Municipal Planning & Design Review Commission
Regular Meeting Agenda
Thursday, August 19, 2021, 5:30 PM
City Hall, Lakeland, Tennessee 38002

Subject: Action on approval of a Site Plan at 3469 Lake District Drive N – Lake District Outparcel 6.

We are pleased to submit the following responses to the staff comments regarding Lot 6 of the Lake District. The original staff comment is shown, followed by our response in green text.

PROJECT: SHADRACHS
LIGHTING CALCULATION

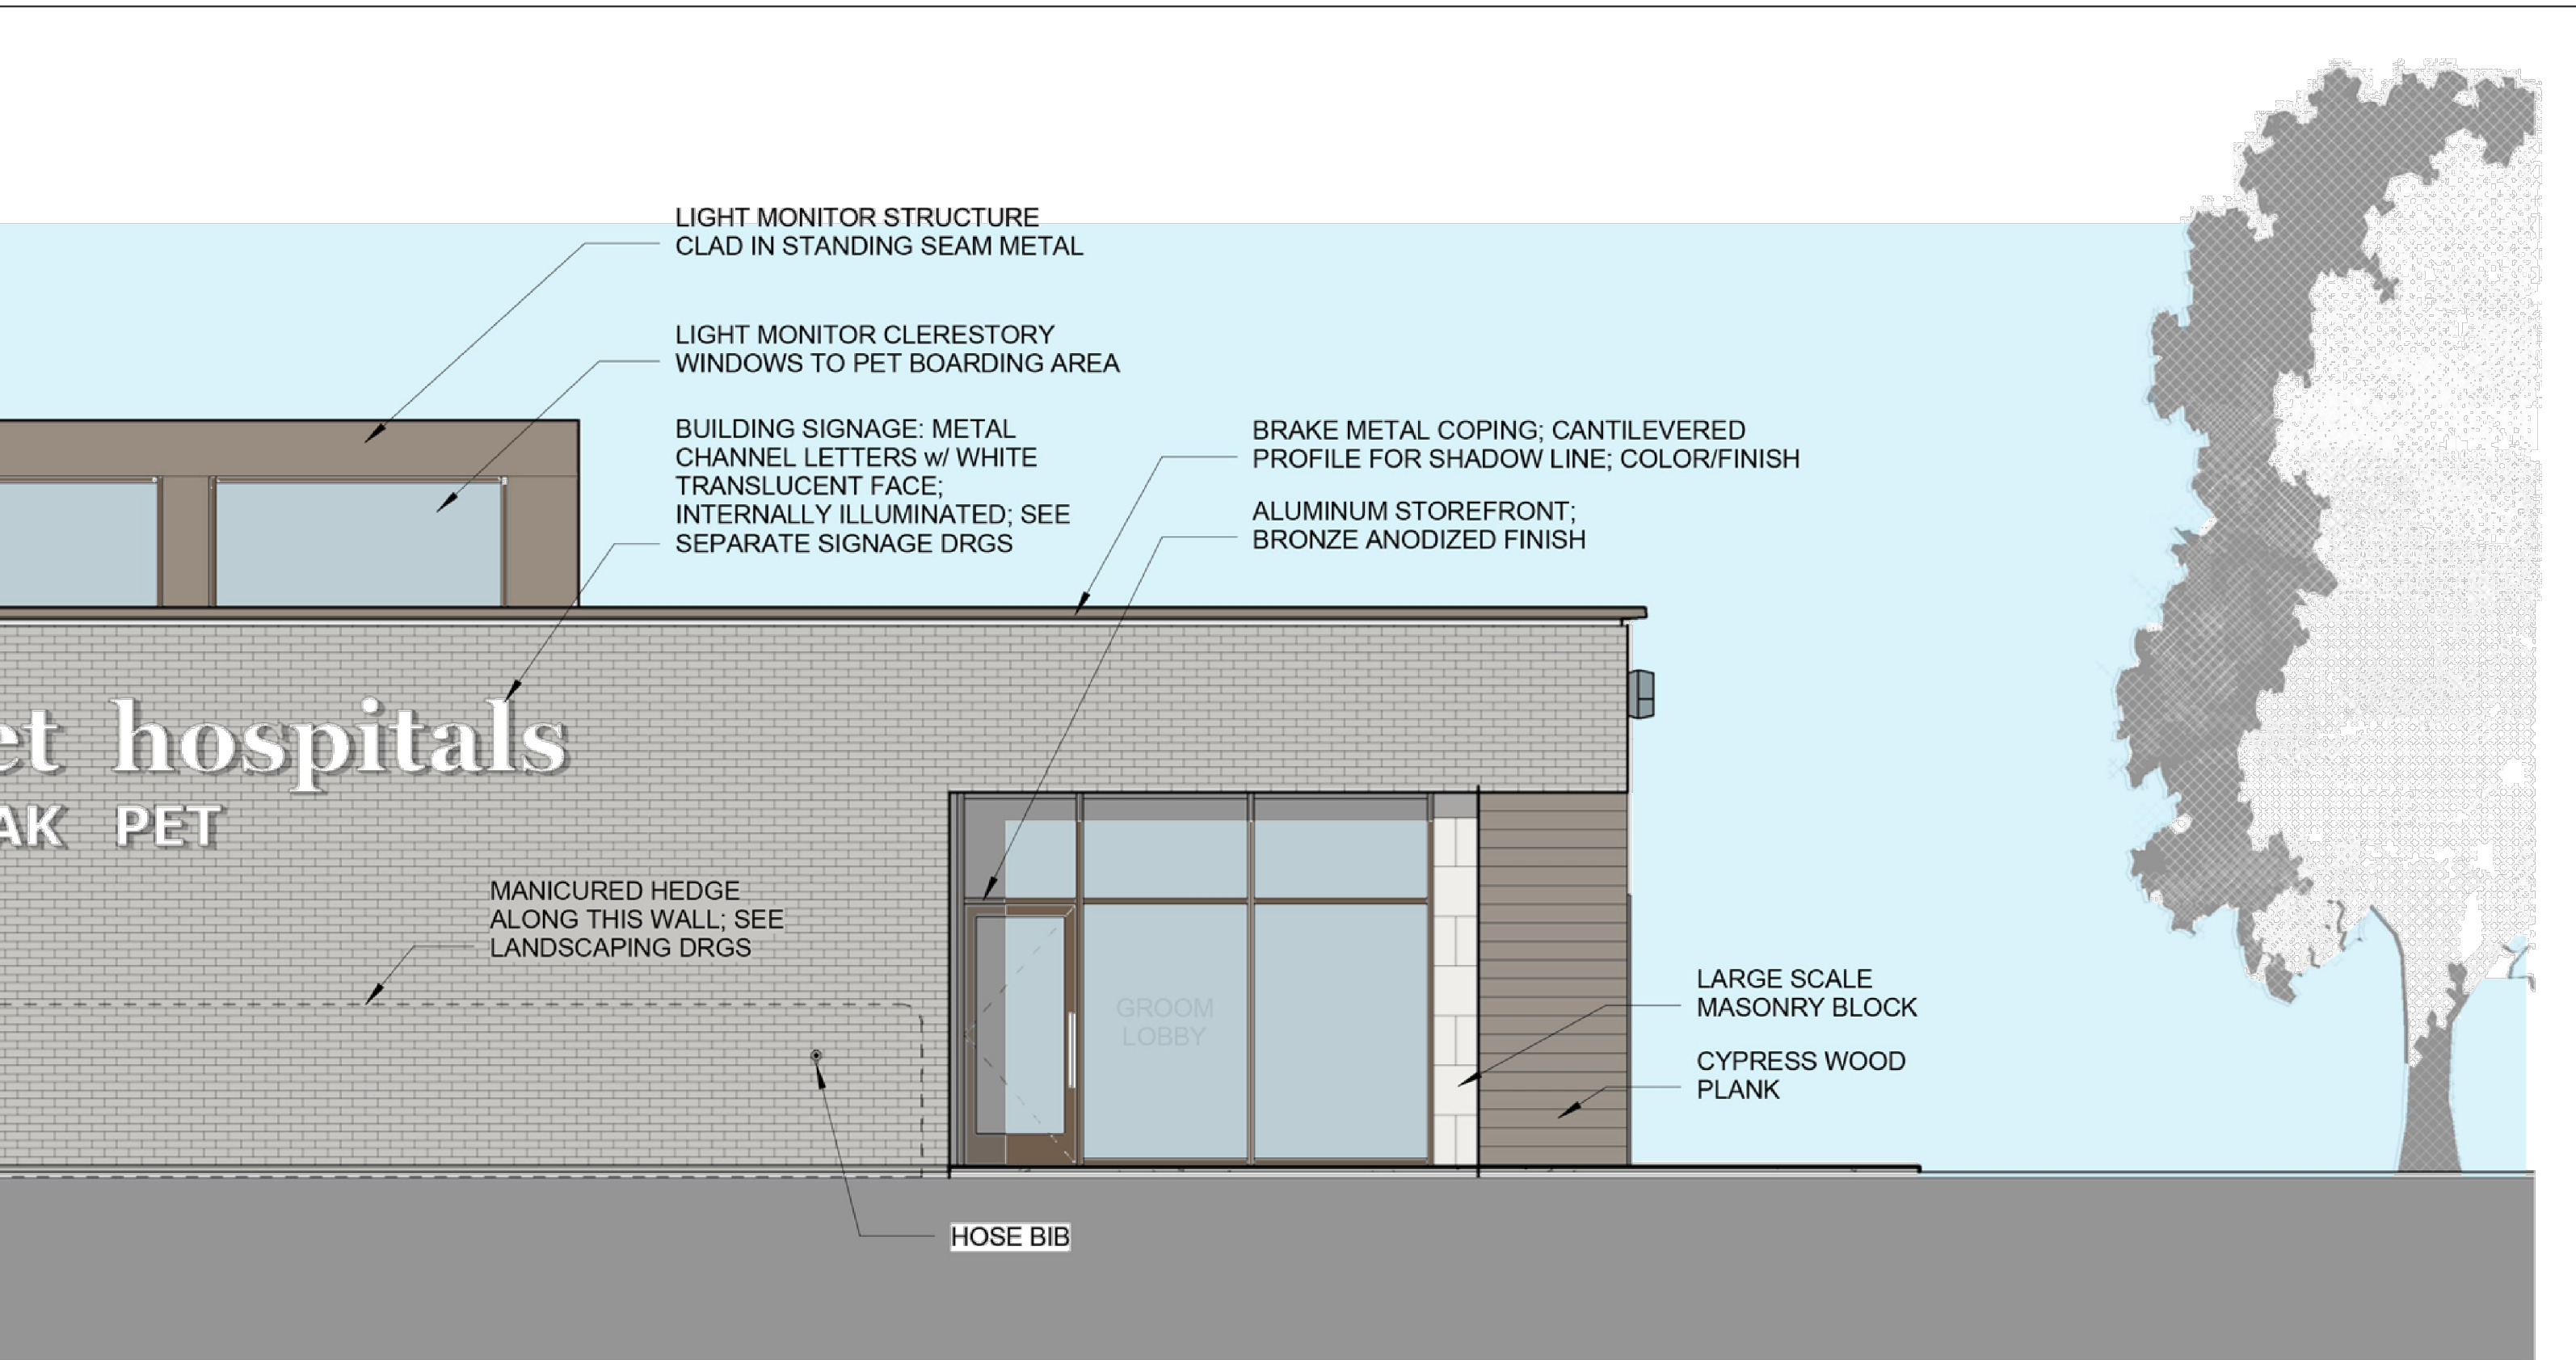
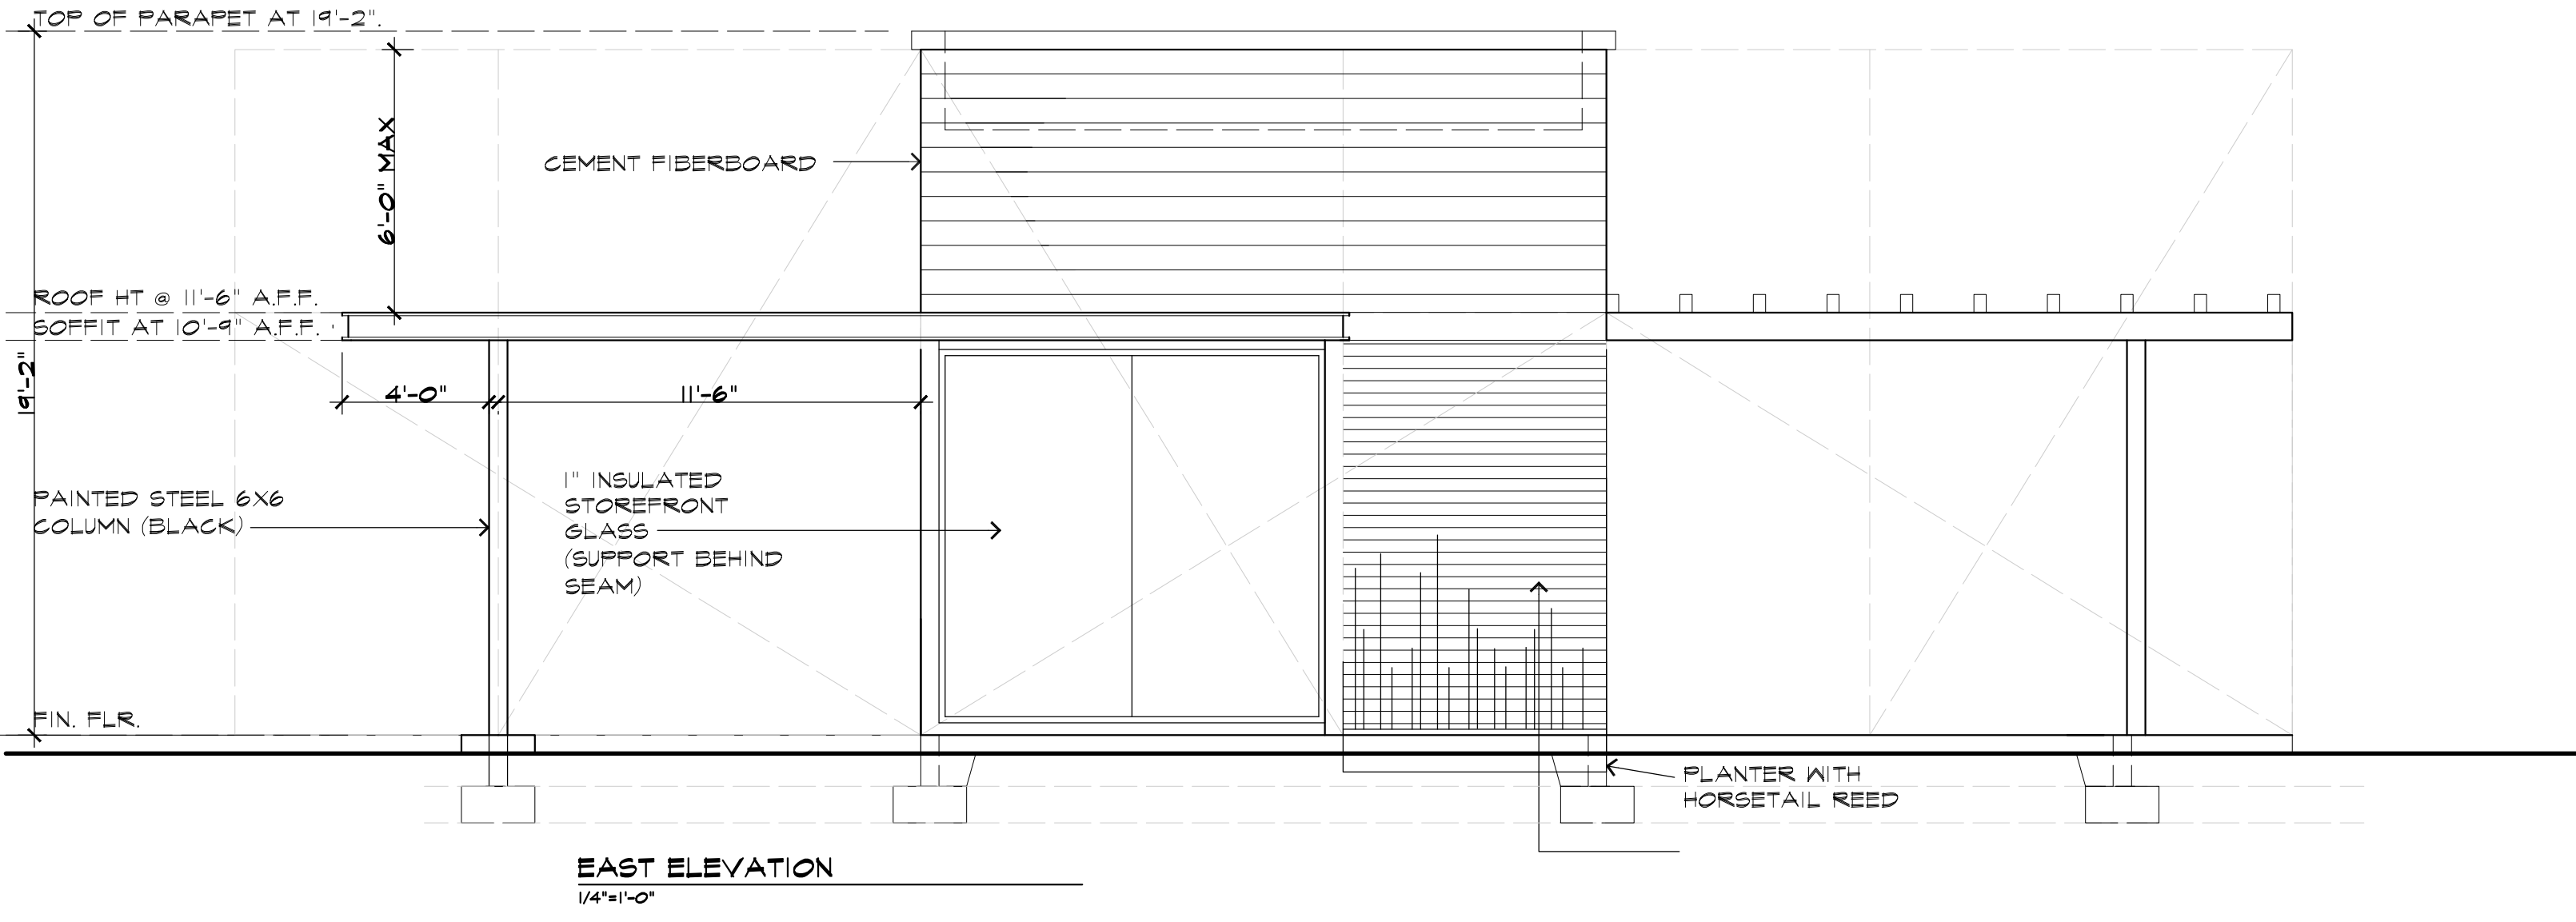
- The site lighting plan that was submitted last month includes several areas that exceed the 1 foot-candle requirement at the property line.
- The foot-candle reading at the property line is as high as 6.4 along the eastern edge and 5.8 along the western edge.

C10.3

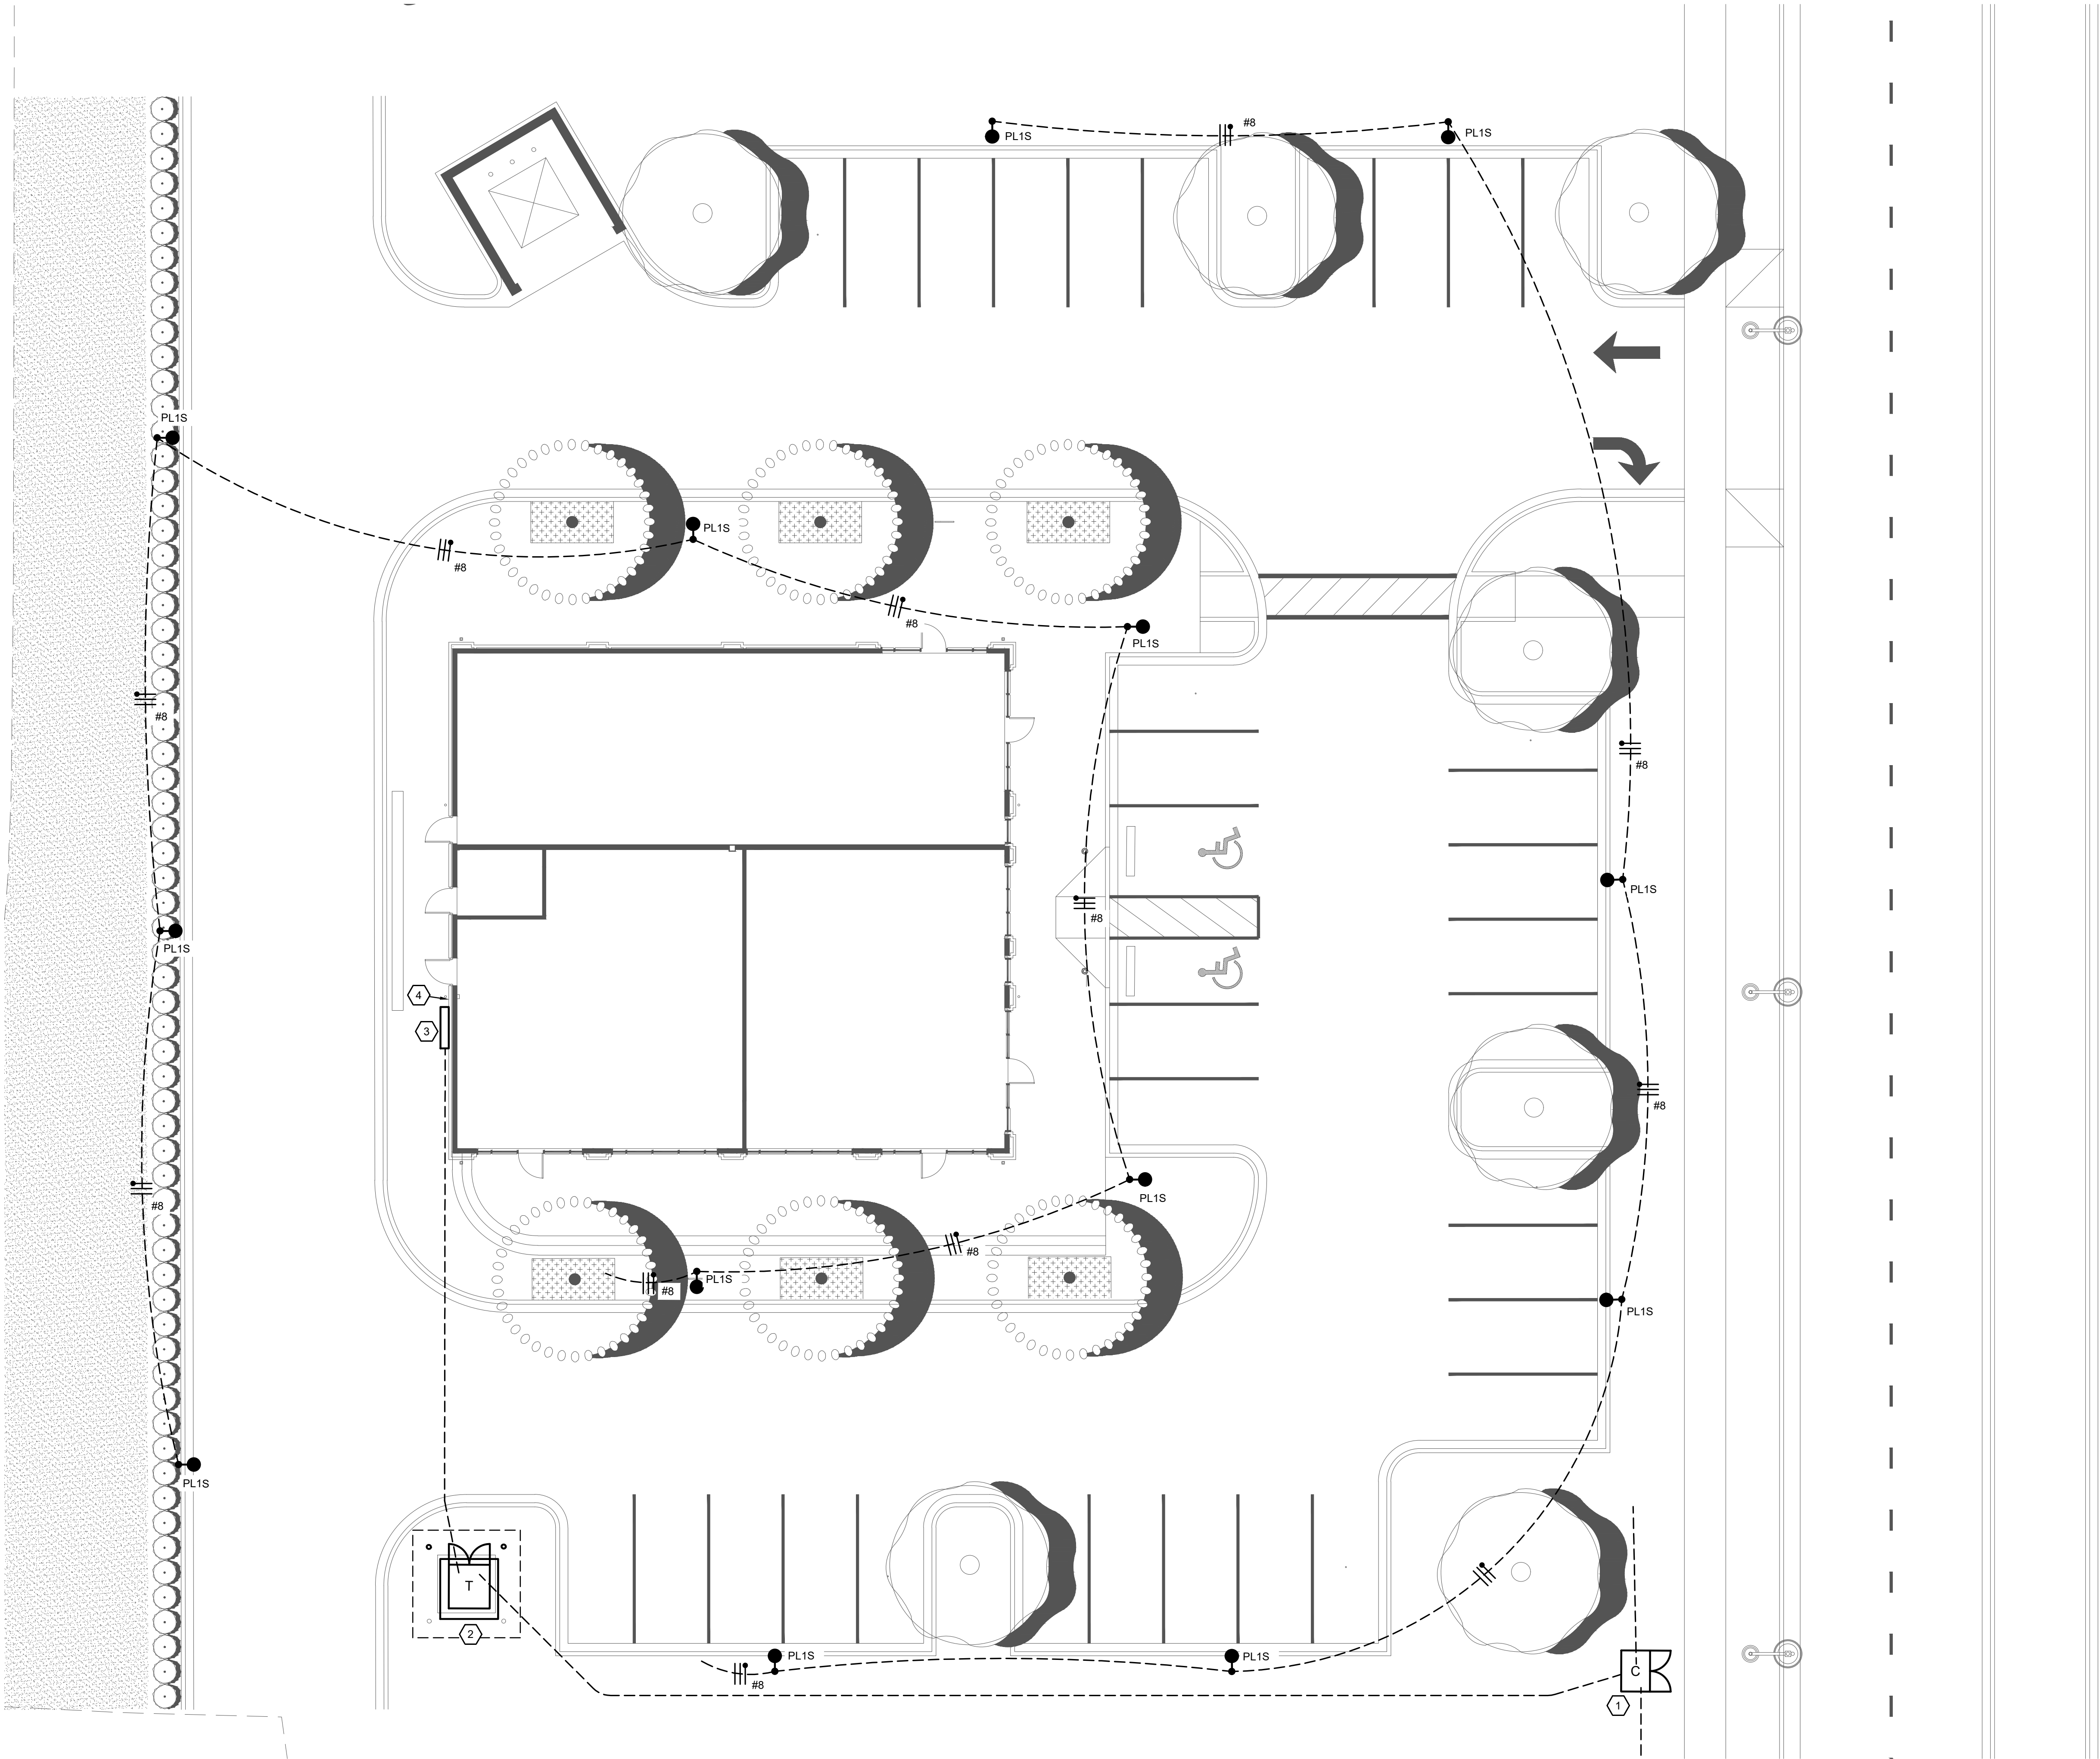
4. Table shows TDOT#10 but detail on 10.3 is for TDOT #12. Please clarify which inlet will be used.
